09 - 2011  
BTD141, BTD141Z, BTD141H2  
18V IMPACT DRIVER KIT

## SERVICE CHANGES

### 1. Changes on Hammer Case Cover and Bumper

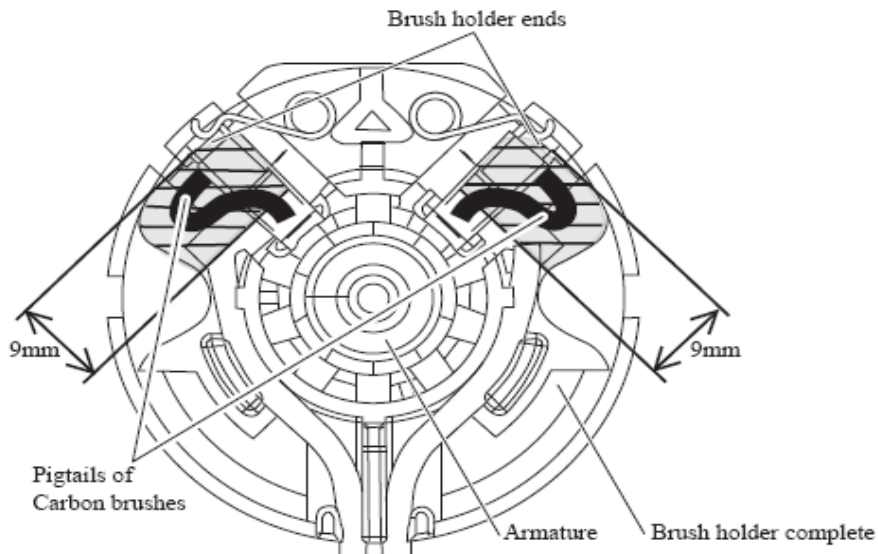
Item No.	Description	Type 1	Type 2
14	Bumper	424015-7	424369-2
15	Hammer Case Cover	450585-0	452409-6

Above parts are completely interchangeable as a set.

Type1: Bumper is hooked with the grooves of Hammer case.

Type2: Bumper is hooked with the protrusions of Hammer case cover as illustrated below.

### 2. Changes How to Assemble Carbon Brushes

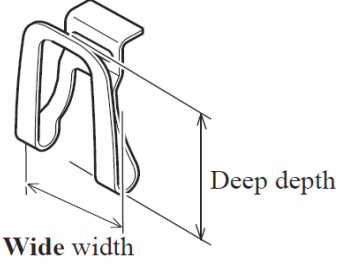
Item No.	Description	Type 1	Type 2
36	Carbon Brush	194427-5 (W/O ORIGIN)	195021-6 (W/ ORIGIN)

Do not protrude the pigtails of Carbon brushes from the specific spaces.

Refer to the following illustration.
